ACCION NEW MEXICO
Regional Headquarters
2000 Zearing Ave. NW
Albuquerque, New Mexico

DRAWN BY RE
REVIEWED BY
DATE 07/24/09
PROJECT NO. 08-0111
DRAWING NAME
SITE PLAN AND PROJECT DATA

TEMPORARY DRAINAGE CERTIFICATION

GRADING AND DRAINAGE

SITE PLAN
1" = 20'

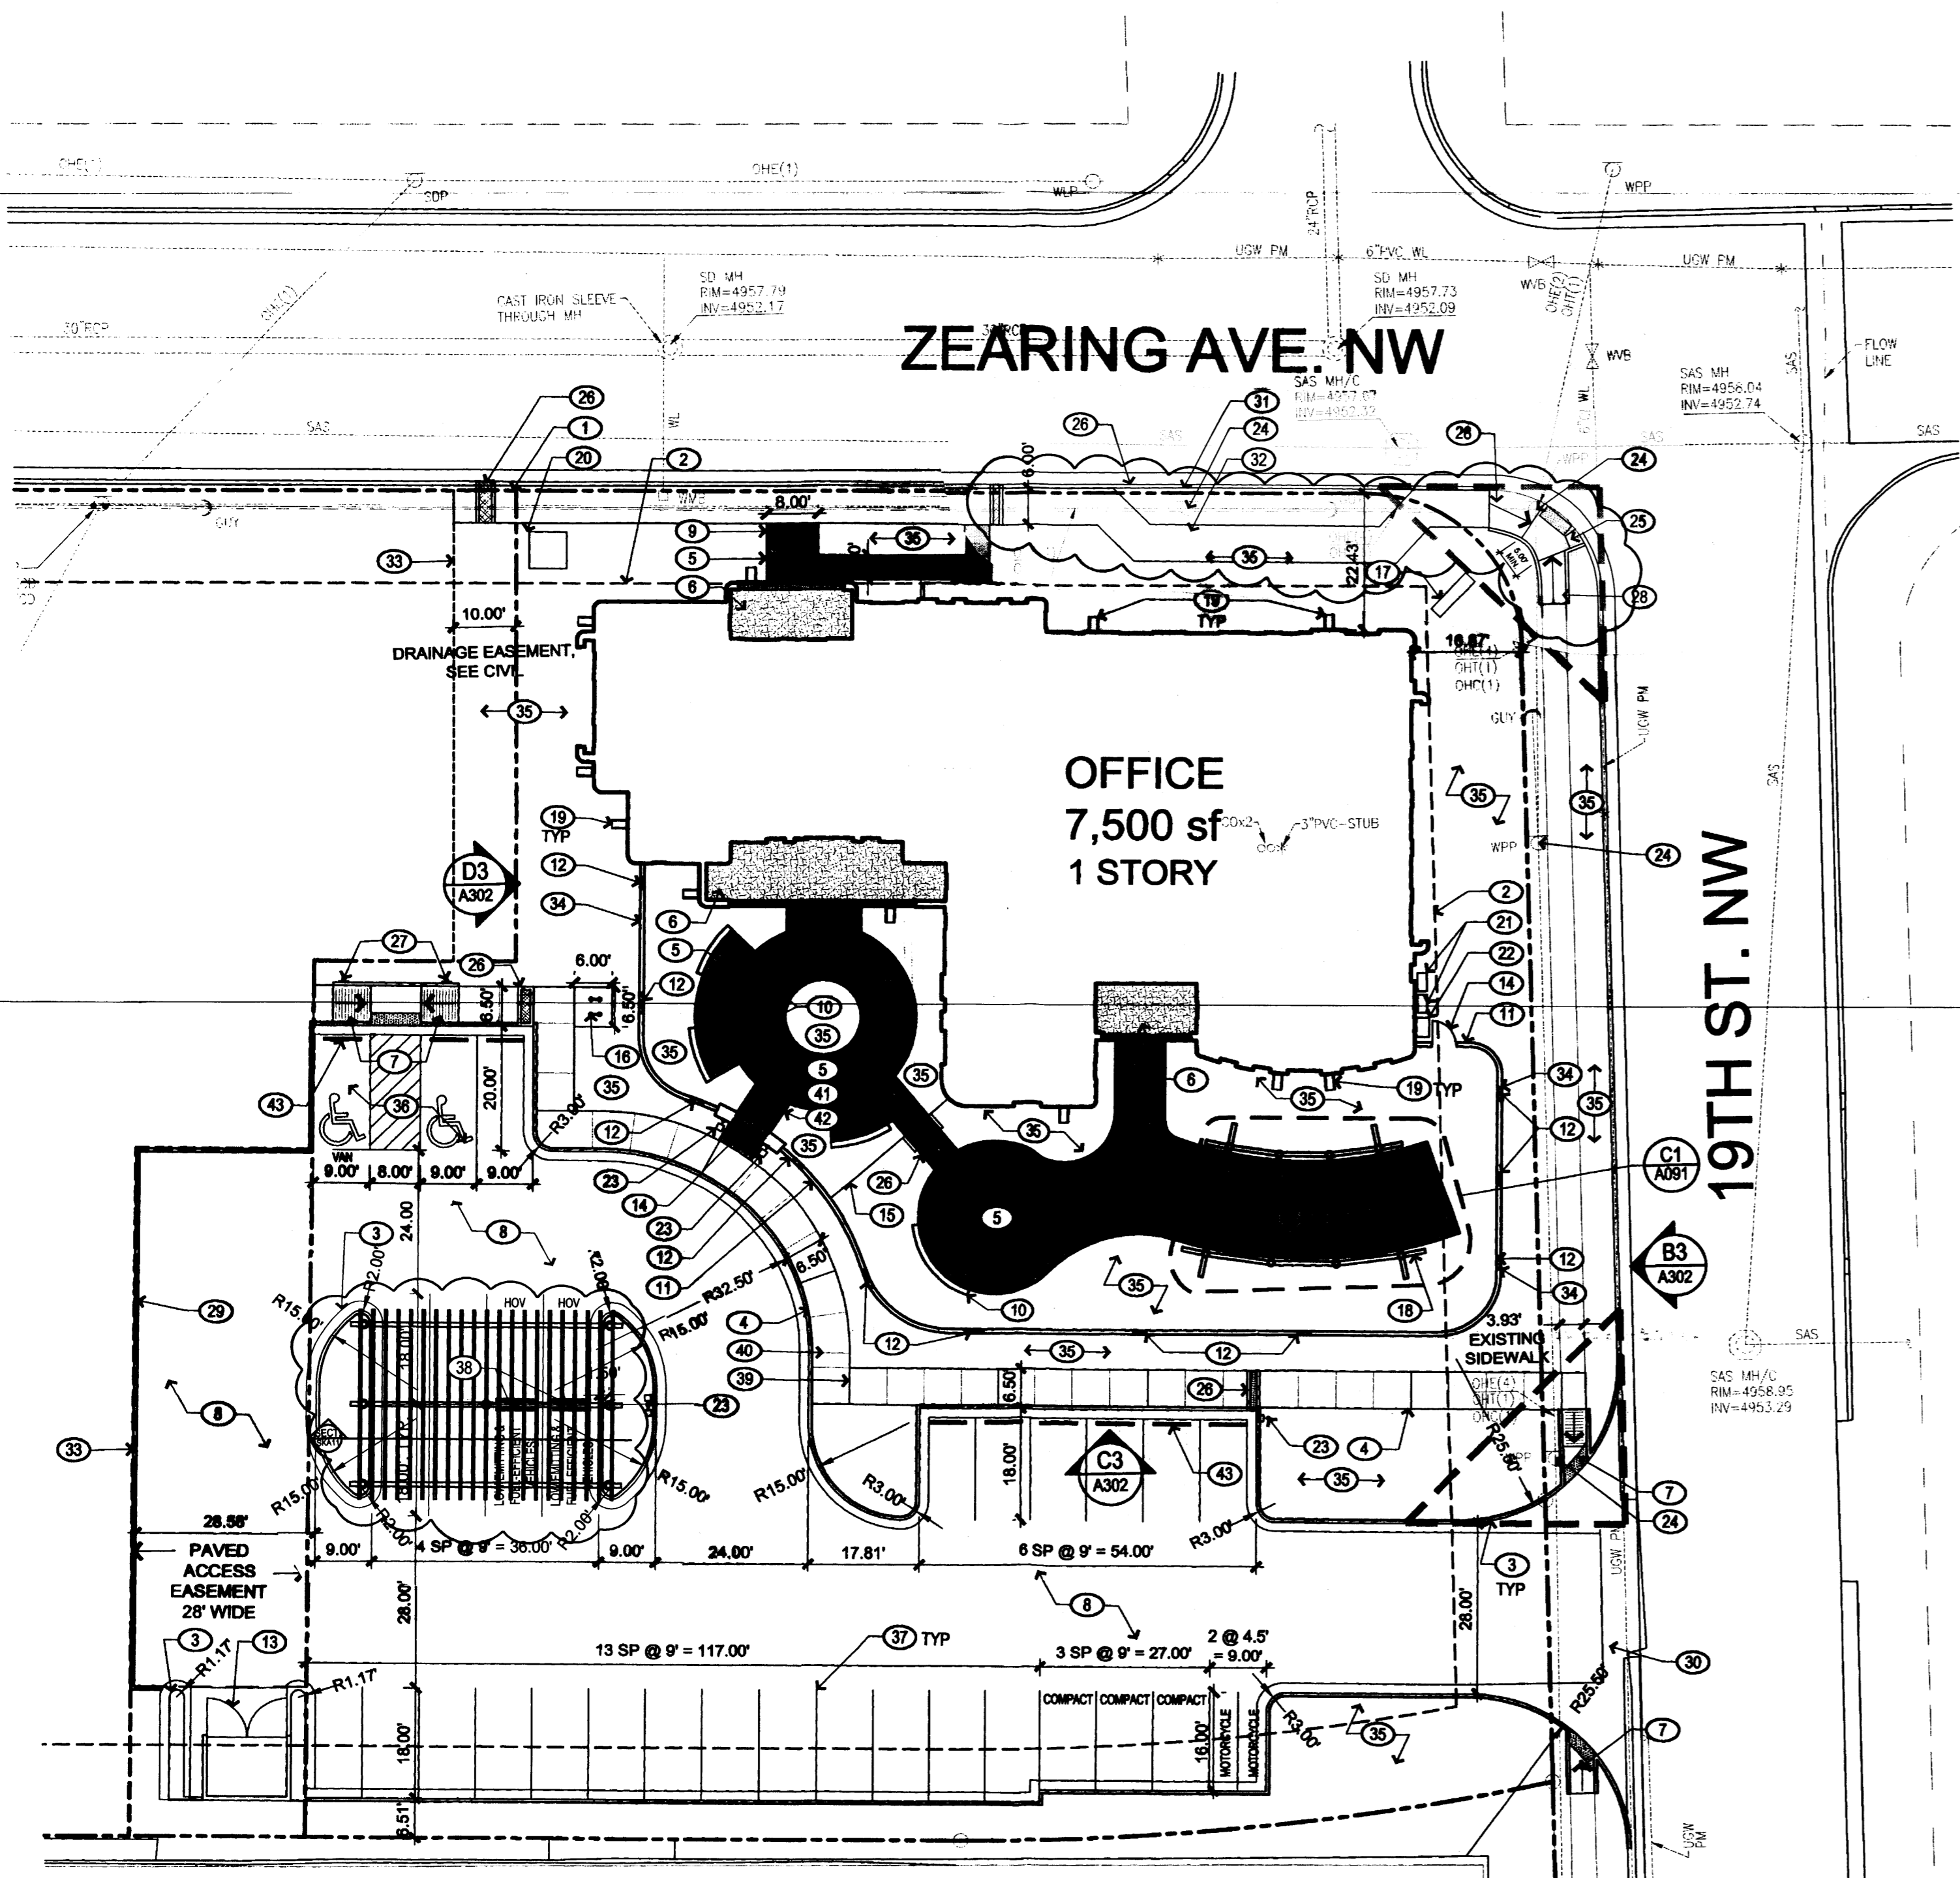
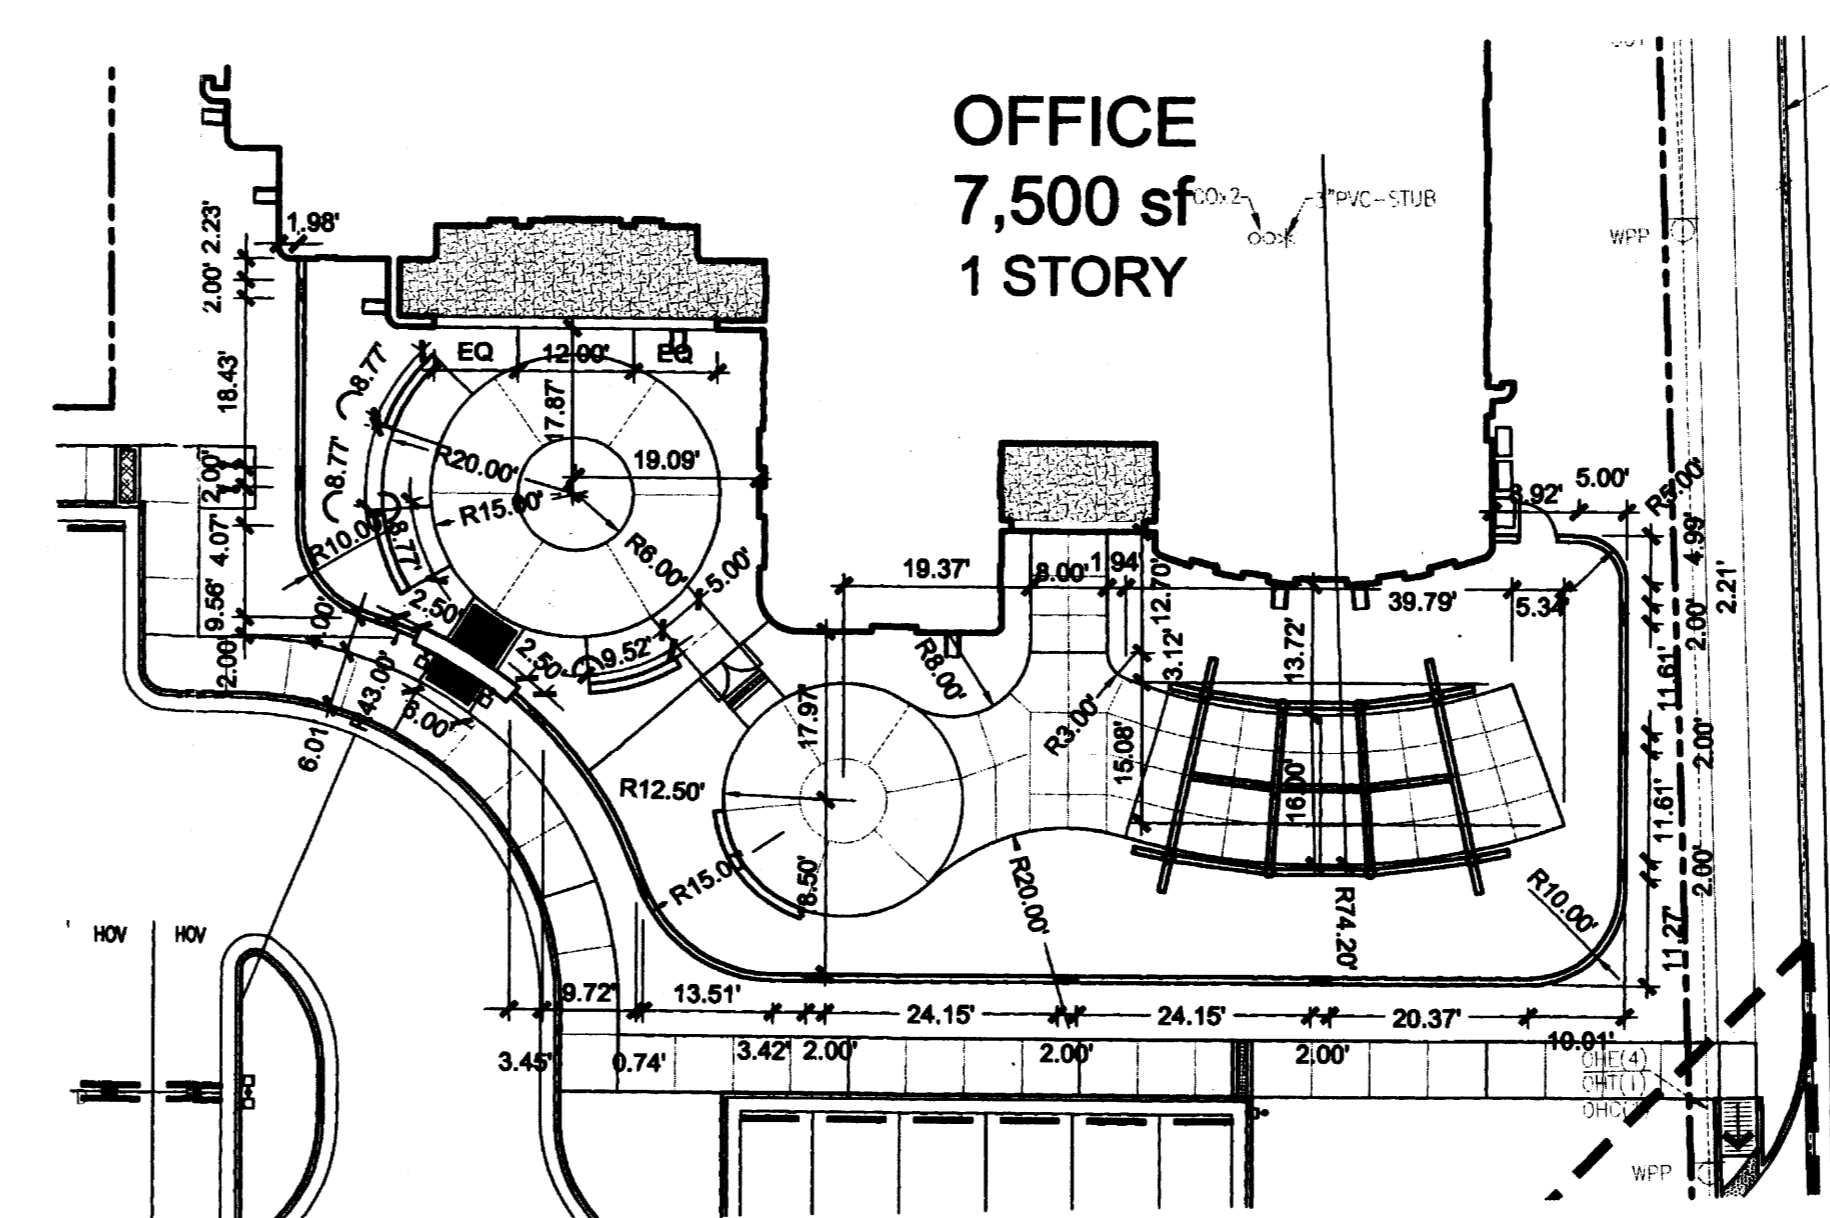
ALL WHEELCHAIR RAMPS LOCATED WITHIN THE PUBLIC RIGHT OF WAY MUST HAVE TRUNCATED DOMES.
